Subject 35 Timber godown
Lea Q.

BUILDING COMPLETION REPORT

Re :—Plot No. 35 Timberghadon Lea Qr.
Sheet No. Lea

PLAN OF PROPOSED TIMBER GODOWN ON PLOT Nos 35 & 36 LEA QUARTER SCALE 8"=1"

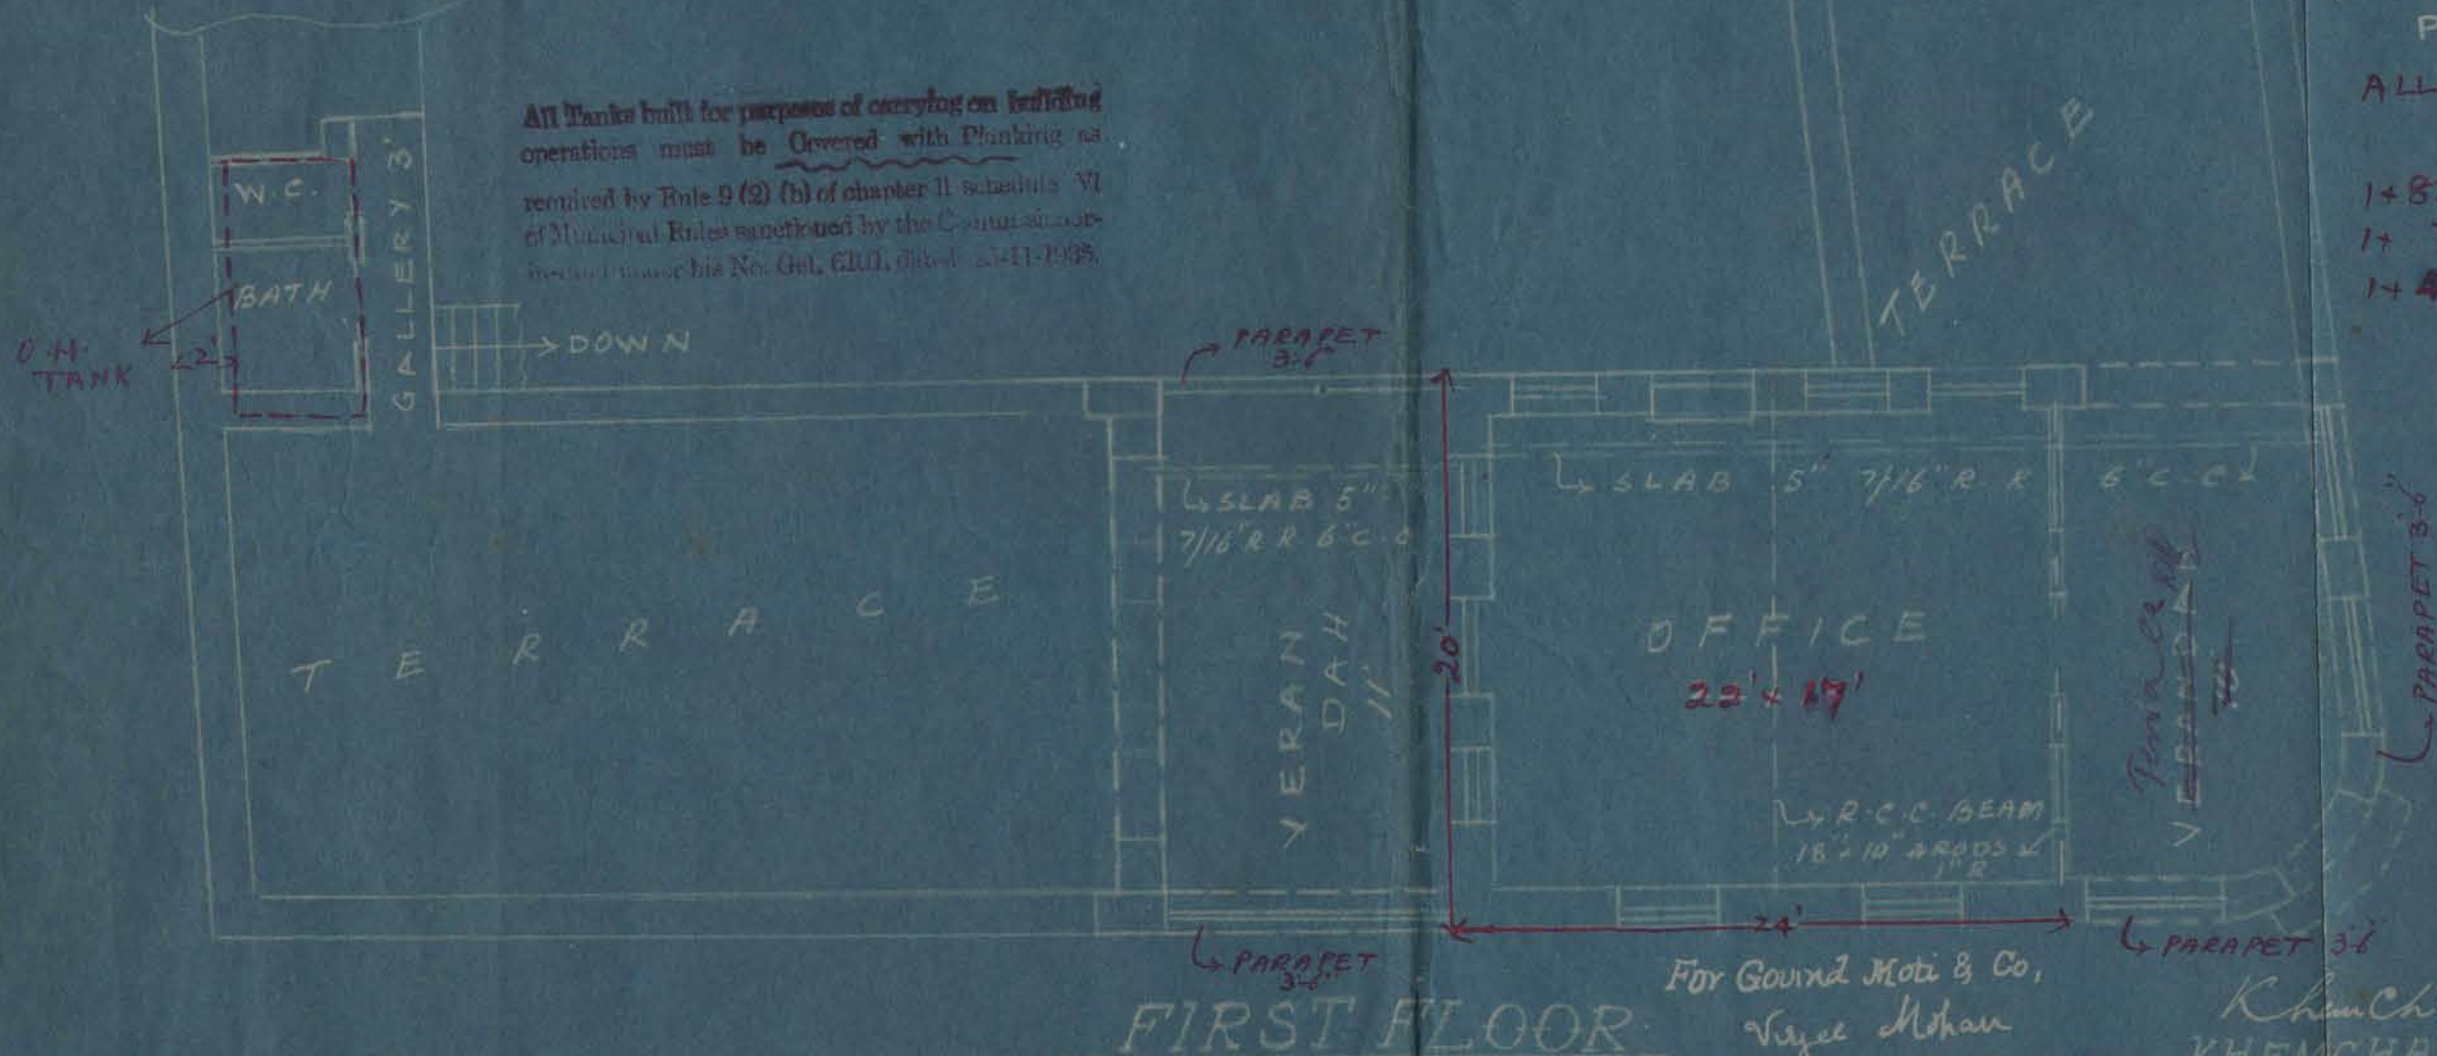
- (1) Built up area and open area and dimensions of structures constructed require correction according to site. For this the architect is requested to have them jointly measured. These ~~max~~ shall be as per conditions of sale. *Complied with*

- (2) Plans require correction as per structures on site. *do*
- (3) A portion of the timber shed on the west is converted into a cow stable with two mangers which cannot be allowed.

- (4) Store adjoining garage is converted into another garage which cannot be allowed. *Complied with*
- (5) Verandah is converted into chowkidar's room while chowkidar's room is converted into a store which is objectionable. *Complied with*

- (6) One of the stores in the front ~~max~~ on the south is converted into an office. *Office shifted to 1st floor*
- (7) Sanitary block on the first floor is not constructed. This must be done. *The part is not. Want it and is deleted from plan. Plan corrected*

- (8) North east corner is *rounded* and plan does not show that Also a door is provided near there on the east.
- (9) Above 8'-6" of wall on the west, north and east, honey-comb C.B. work is provided which cannot be allowed except on roads.

- (10) Other objections of Land S., Health O. and Assistant E. if any will be communicated later on. *No objection*
- (11) Building is unauthorisedly occupied for which prosecution is being filed. *Ball*
This is
The plans are returned herewith rejected

- (12) A pit for motor cleaning is provided in front of sanitary block which cannot be allowed. *Yours faithfully,*

- (3) The owner has absolutely dropped the idea of keeping the cows in the godown
- (2) The pit is being filled up
- (1) The honey-combed openings are being closed.

1. Built-up area has been checked with the B.S. and noted down.
2. Plans are corrected
- x 3. This is only a shed and the owner's own Cons will stand there for which proper sanitary arrangements has been provided, your attention has been drawn by a dwarf wall 5' high which shows a separation and this is only a fire caution against the animals jumping on the other side, as otherwise there is nothing objectionable.

4. Sometimes the Manager's car will be in this store otherwise it will be used as a store.
5. Changes are being made as per plan.
6. The little seen there has been removed to

7. Floor and the same will be used as store
7. This is not necessary
8. Corner is rounded & floor shown
9. This is done on one side on west and my client agrees to close if asked at any time by Corporation or adjoining owner
